**ADDENDUM NO. 3**

**PROJECT:** Rotary Park Restrooms Rebid & Grinder Lift Station Project  
IFB #16-542  
Wentzville, Missouri

**SUBJECT:** Addendum No. 3  
Cochran Project No. M14-7119 (15-6060)

**Sheet A1.2**

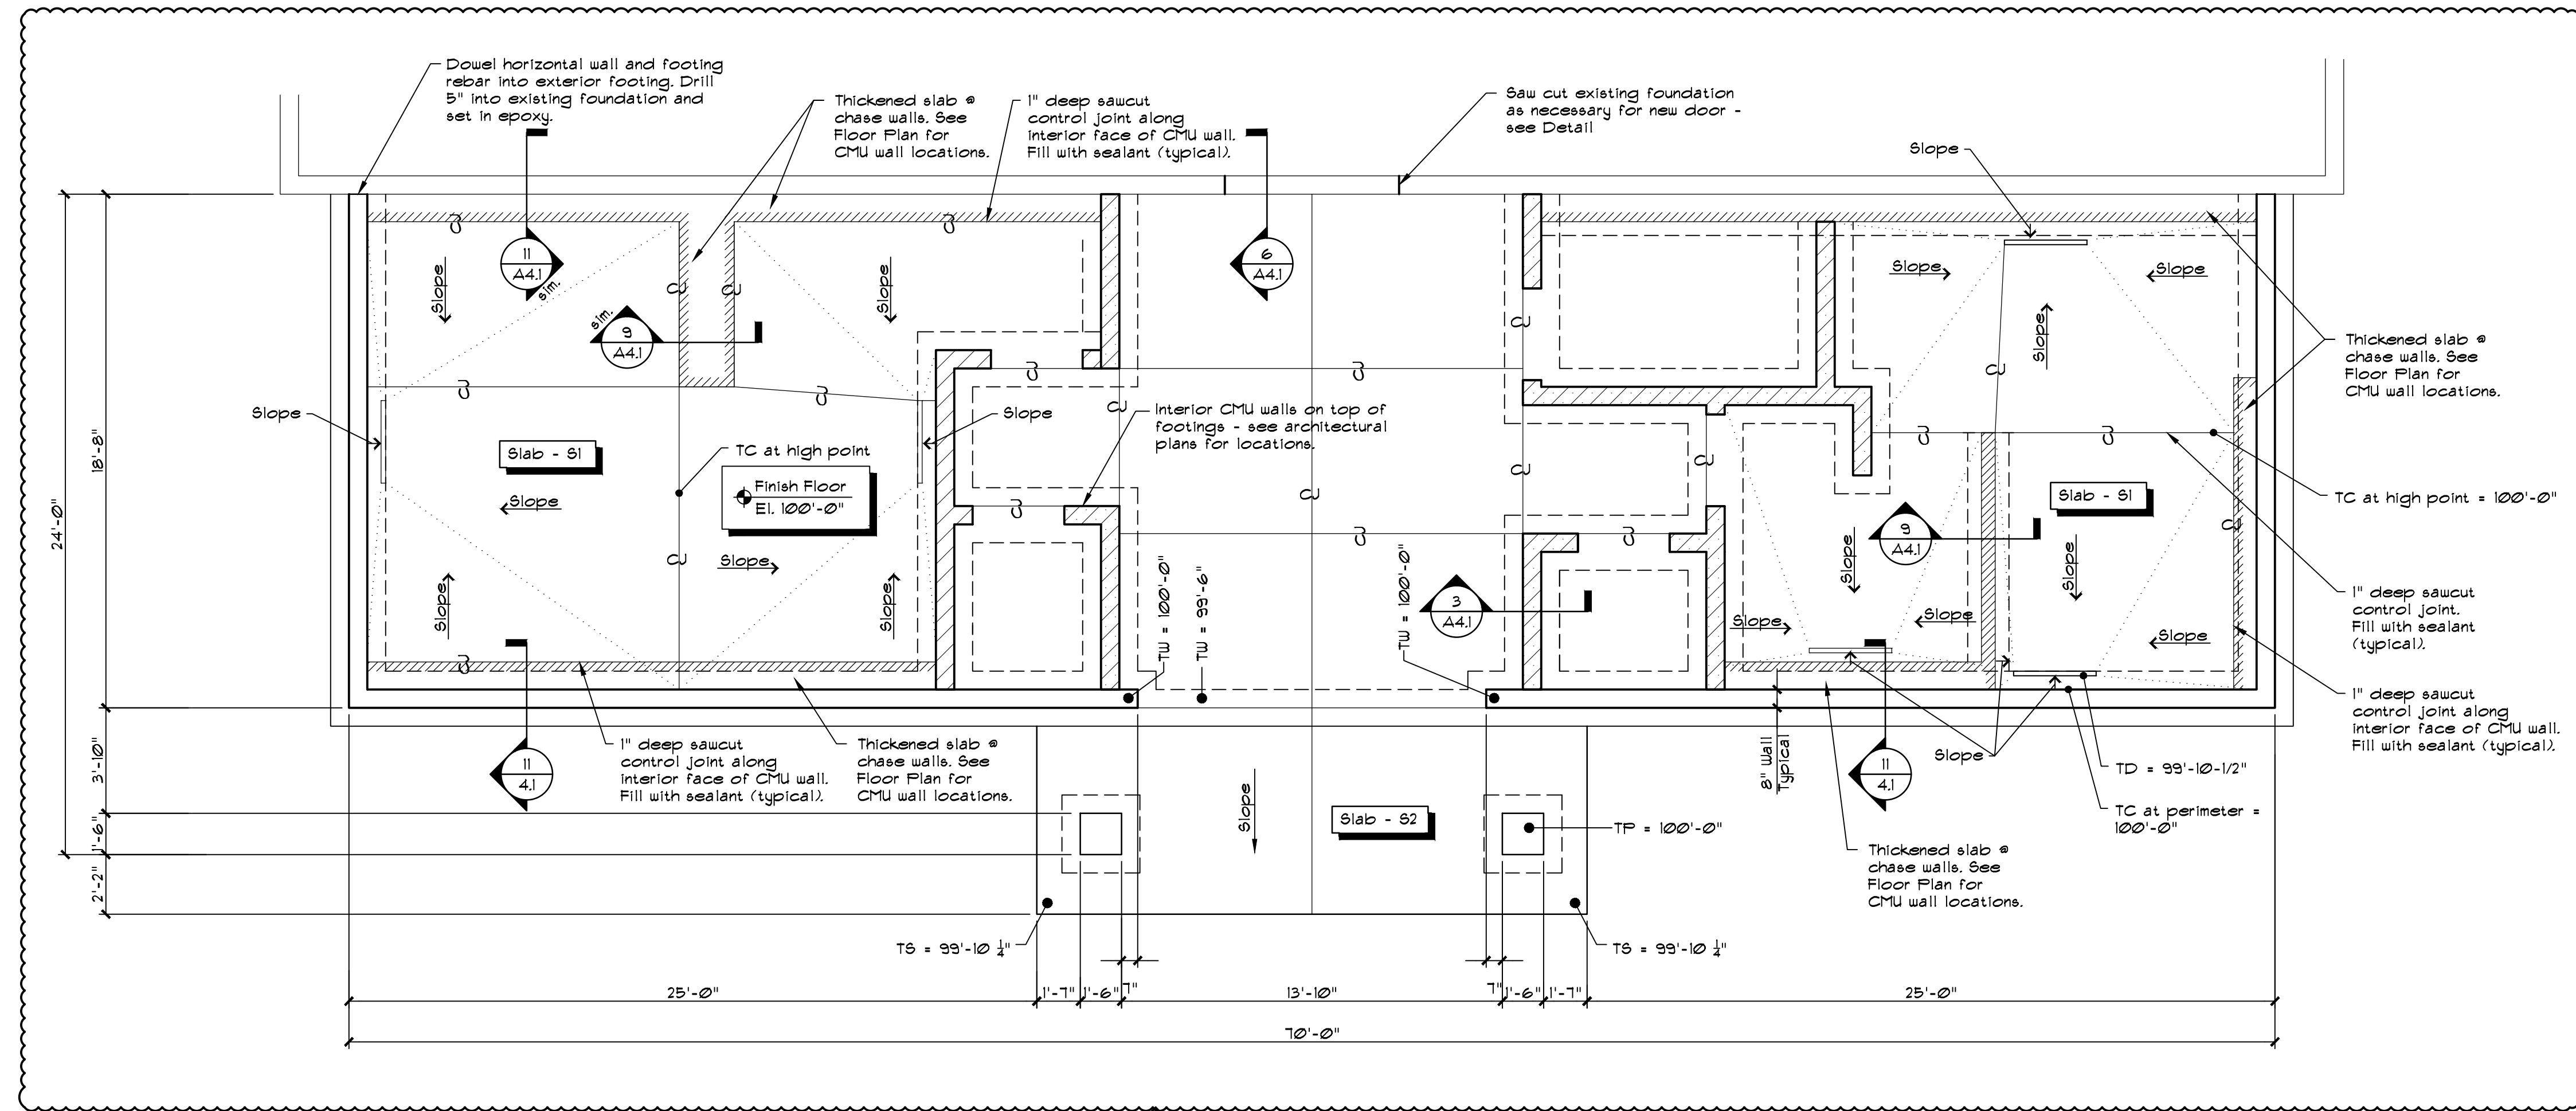
3. Clarification: Clarify locations of thickened slabs and control joints. Indicated locations of detail sections.

**9 SECTION TYPICAL THICKENED SLAB**  
3/4\"/>

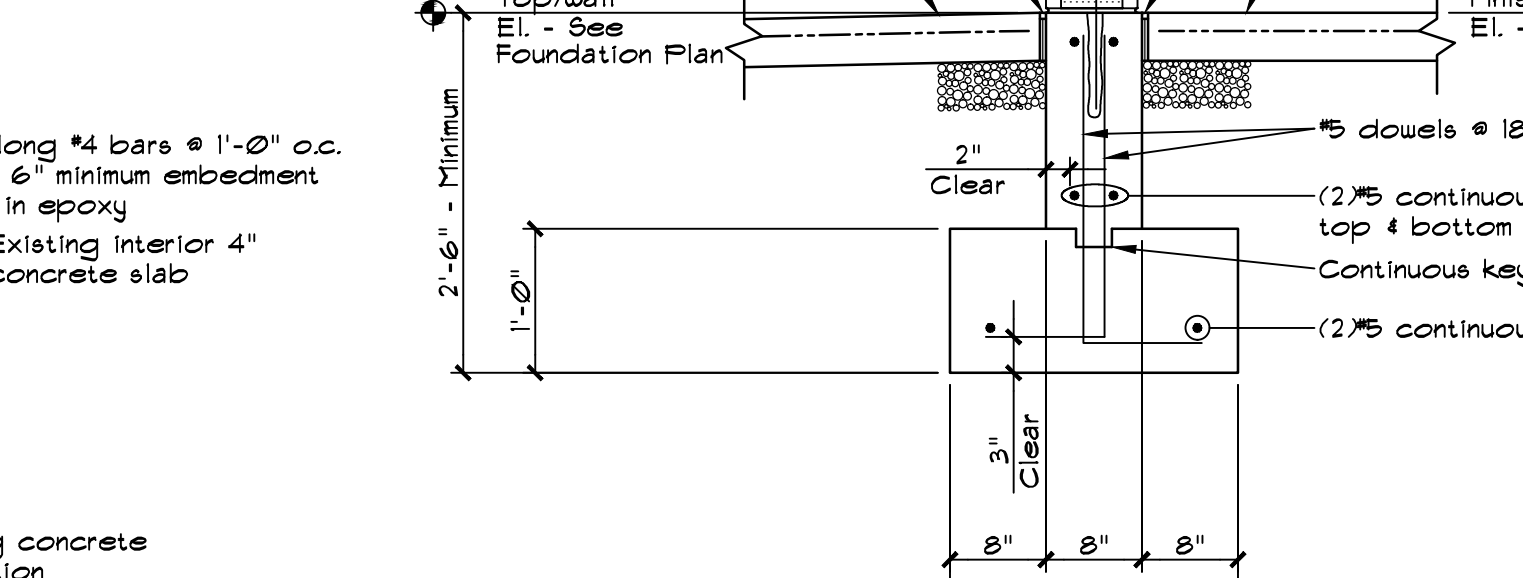
4. Clarification: Provide new Detail 11/A4.1 to indicate the chase wall located at the exterior wall.
5. Change: Changed the thickened slab section 9/A4.1.
